Modification request to amend the approval for the M2 Site, North Ryde Urban Activation Precinct (SSD5093MOD4)

**Re: LACHLAN'S LINE PEDESTRIAN BRIDGE - DELI ROAD / M2 MOTORWAY NORTH RYDE
NORTH RYDE STATION URBAN ACTIVATION PRECINCT 75W PROPOSAL
BUSHFIRE ASSESSMENT COMMENT**

Peer Review of the Biosis Pty Ltd ecological consistency assessment, Lachlan's line pedestrian bridge

Image 01 – Extract from the City of Ryde's Bushfire Prone Lands Map
Noting that the subject Piers are not deemed as being bushfire prone.

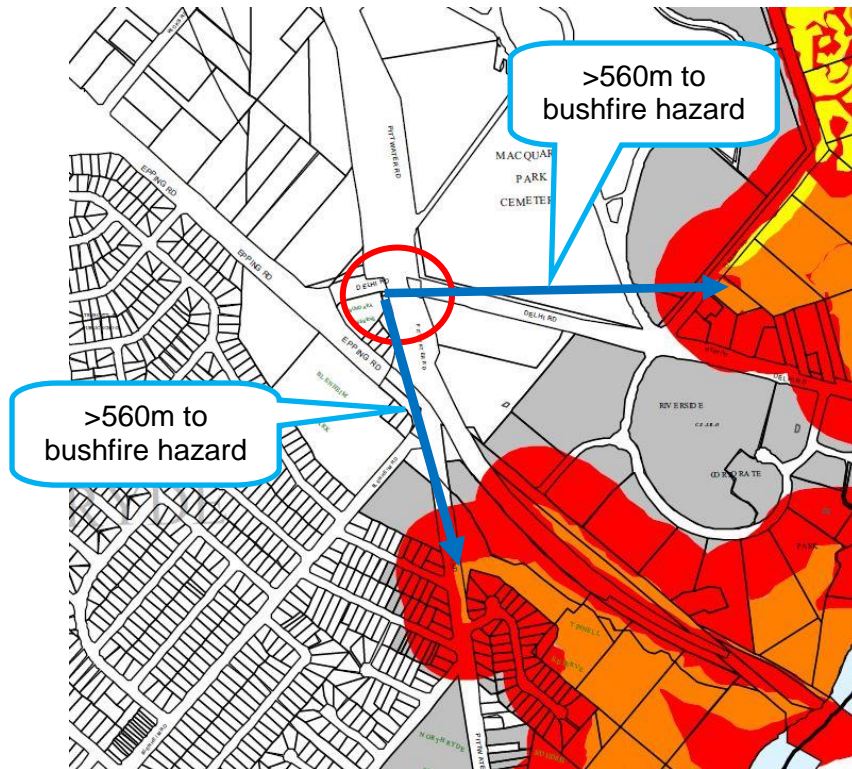
In this instance the subject land sites (Pier 2 and Pier 3) are not identified as being '*bushfire prone*' on a City of Ryde 'Bushfire Prone Lands Map' as certified by the Commissioner of the NSW Rural Fire Service. Therefore the application of '*Planning for Bush Fire Protection – 2006*' and '*Australian Standard 3959 – 2009*' is not formally triggered under section 100B of the *Rural Fires Act 1997* or section 4.14 of the '*Environmental Planning and Assessment Act – 1979*'.

Image 02 – Extract from NSW Government Portal's Bushfire Prone Land map
noting that the subject Piers are not deemed as being prone to bushfire impact.

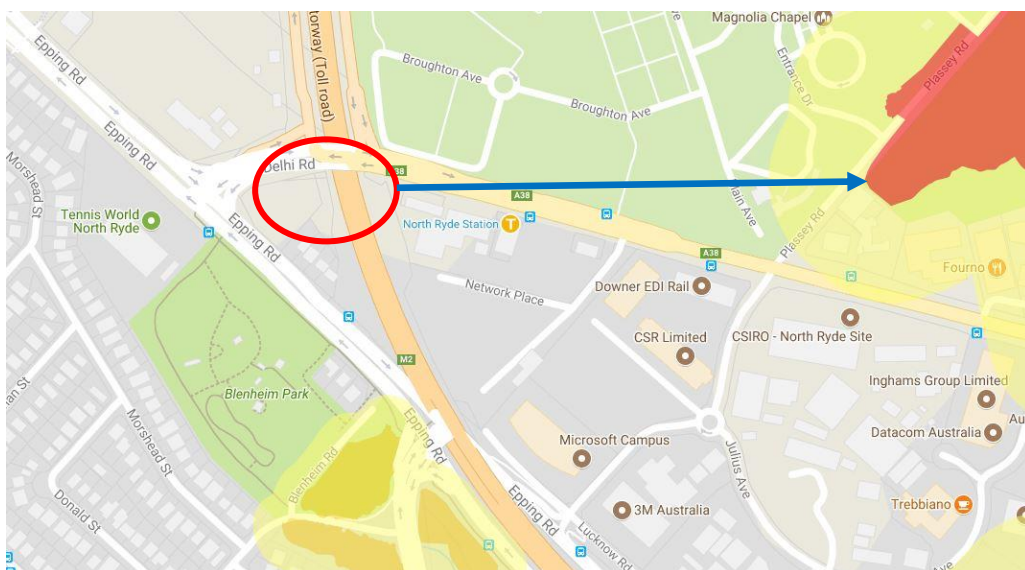
Bundara Reserve is not referenced as being bushfire prone in the City of Ryde Council's Bushfire Prone Lands Map. Nor is it listed as being bushfire prone on the NSW Rural Fire Services self-help web page or the NSW Government Portals mapping system.

Image 04 – Extract from Willoughby / Ryde Councils Bushfire Risk Management Plan – 2010
Noting are 61 as being Bundara Reserve

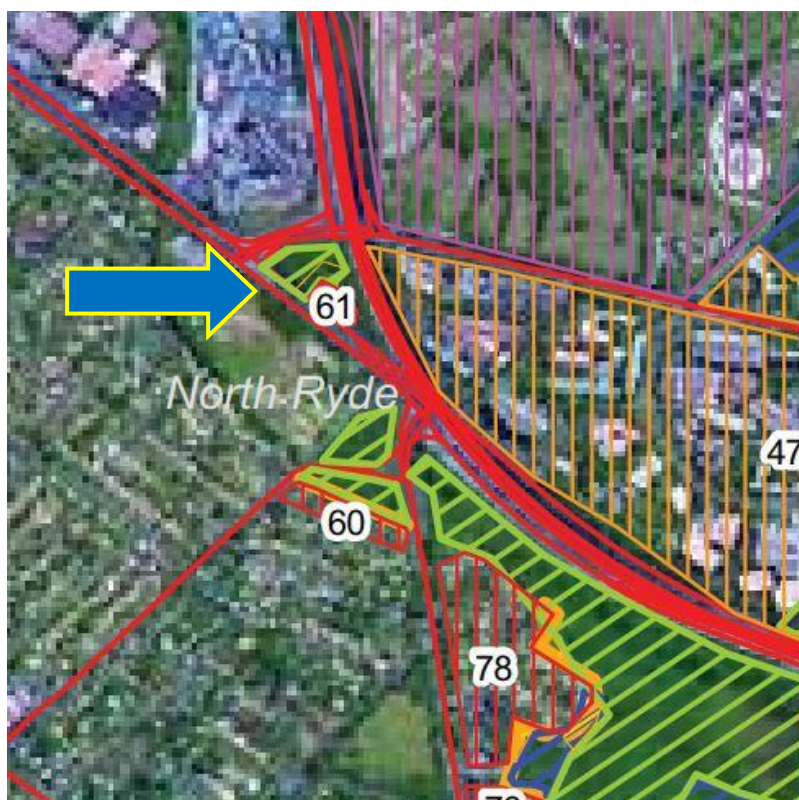
Bundara Reserve is managed by the City of Ryde Council and is listed in the Willoughby / Ryde Councils Bush Fire Risk Management Plan - 2010 as a Land Management Zone (LMZ) and is listed as item 61. Whilst being rated as a Very High risk in this plan the priority rating is only 2A.

Bundara Reserve is however listed as item 61 in the Willoughby / Ryde Council's Bushfire Risk Management Plan and as such is managed by Ryde Council.

Image 03 – Aerial view of Bundara Reserve noting open space below tree crown level

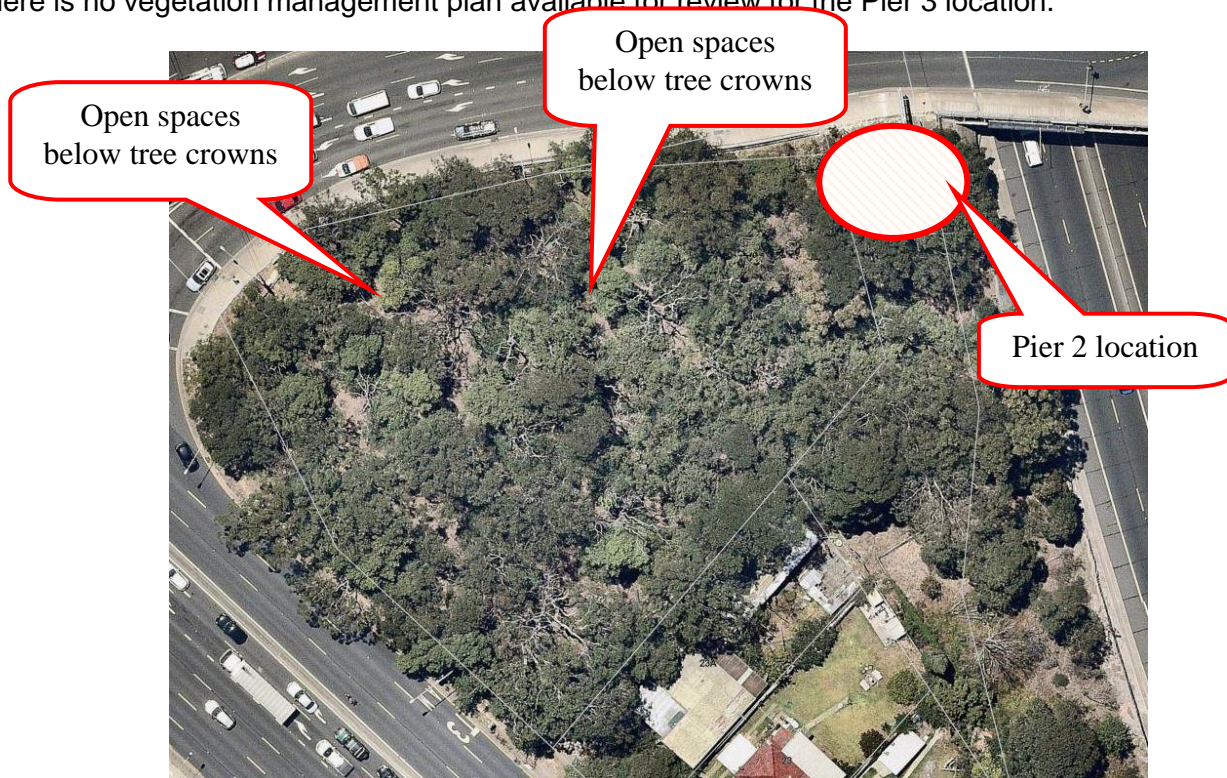
The following image indicates that there are several open spaces at ground level throughout the Reserve suggesting limit low level vegetation. Indeed when viewed from Deli Road or Epping Road a person can see through the forest suggesting very limited scrub and intermediate vegetation layers.

This type of vegetation management may be in concert with STIF management practices.

Attachment 1: Arborist Report Tree Location Plan 1 and Biosis Figure 1

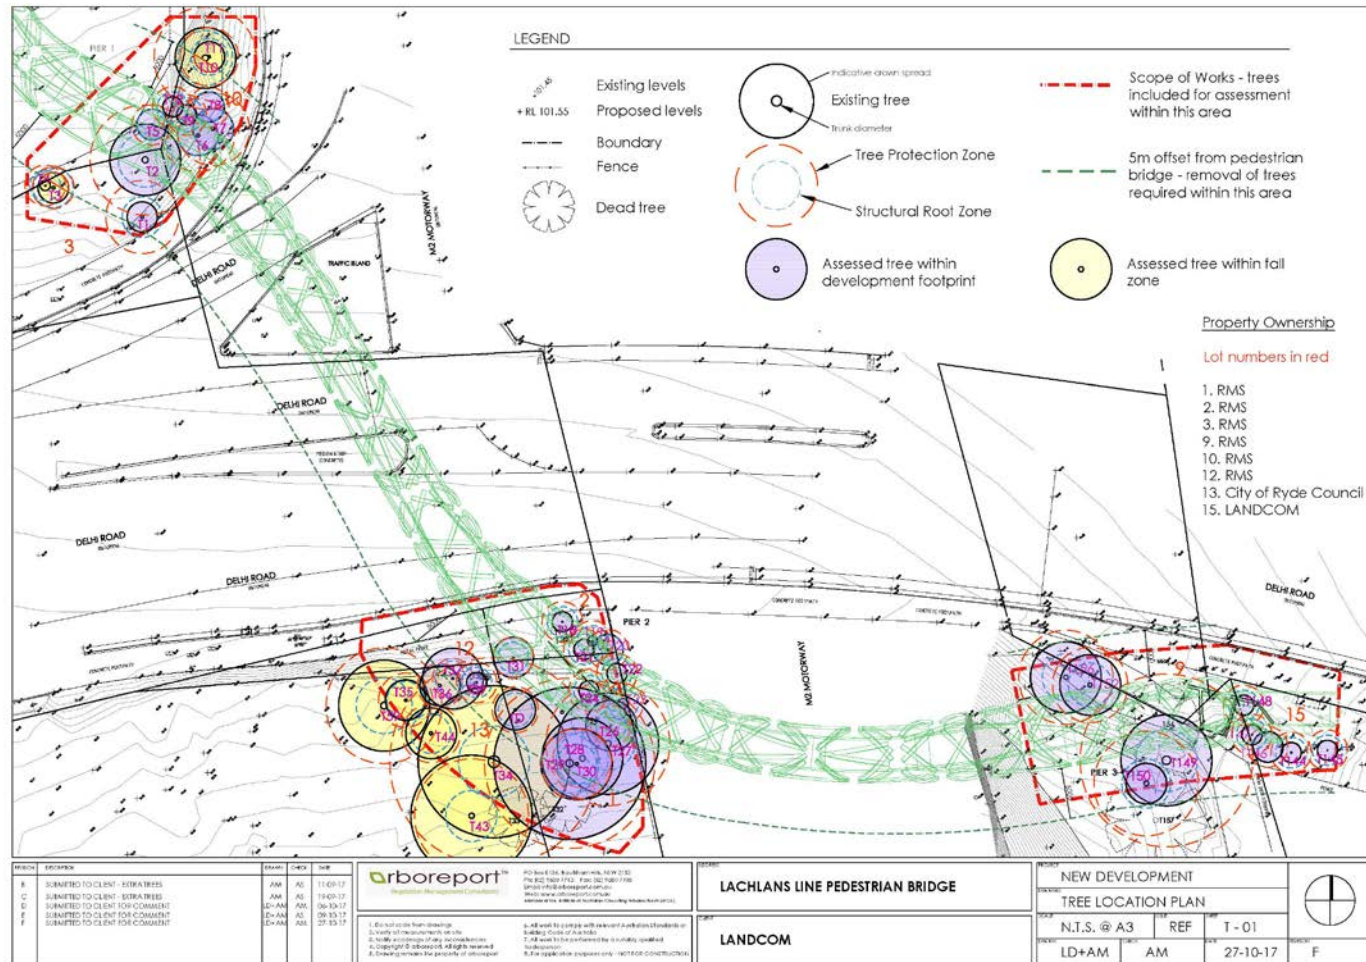
The Tree Location Plans provided in the arborist report do not have a scale (pages 21 onwards) (Attachment 1). Figure 1 (Attachment 1) of the Biosis report does have a scale but the extent of vegetation disturbance does not appear consistent with that identified in the arborist report. It is unclear if the extent of disturbance identified in the arborist report includes the area previously assessed by Ecological. If the area assessed by Ecological is included in the area of disturbance determined by the arborist report, it would mean the figure supplied to Biosis and drawn on in their Biobanking Credit Calculations would be incorrect. Without a consistent figure showing the limits of impact (both direct and indirect) it is difficult to calculate the exact extent (square meterage) of vegetation disturbance (due to both direct and indirect impacts).

- 5) Improved mapping should be prepared to determine the extent of Sydney Turpentine-Ironbark Forest that is to be disturbed
 - a. following this a review of the 7 part test prepared on the Sydney Turpentine-Ironbark Forest should be undertaken, a worst case scenario being adopted when determining the offset calculations
